Palisades Nuclear Plant: 27780 Blue Star Memorial Highway, Covert, MI 49043

DOCKET 50-255 - LICENSE DPR-20 - PALISADES PLANT -  
UPPER SHELF ENERGY IN REACTOR BELTLINE

LOW UPPER SHELF ENERGY MATERIAL  
IN REACTOR VESSEL BELTLINE  
(PLATE MATERIAL IN TRANSVERSE DIRECTION)  
(FINAL)

Figure 4.1

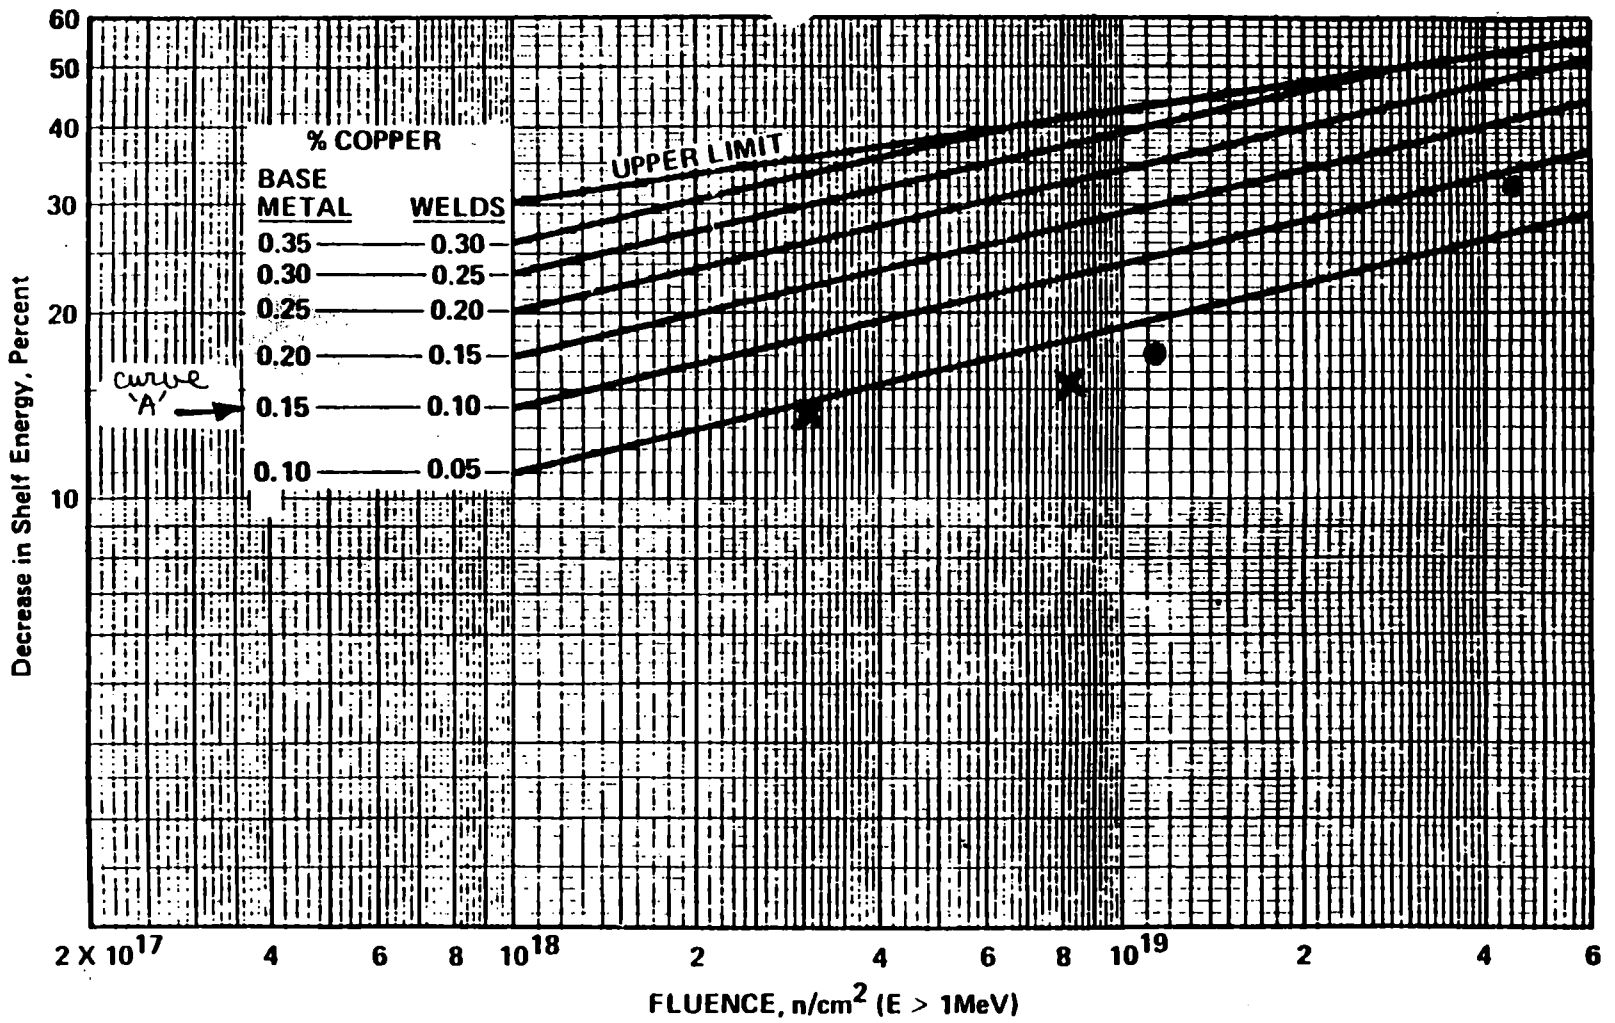
Document Title		Document Number	Revision	Revision Number	Page 1 of 1
Item Number	Page and/or Section Number	Comments		Response or Resolution	
1		Should indicate that the Indian Point data are for comparison purposes only - R6.1.89 does not allow use of other plants' surveillance data.		In section 4.3.4 a note added	
2		Some discussion is necessary here as to why only the base metal enters into the use question.		Section 5.3 <sup>23</sup> was addressing this issue. See also Section 5.4.	
3					
Reviewer		Organization	Date	Review Coordinator	Date
[Signature]		LED/OT	8/22/90	O.P. Jolly	8/22/90
Document Sponsor		Date

Note: Data for Indian Point 3 are for comparison only.
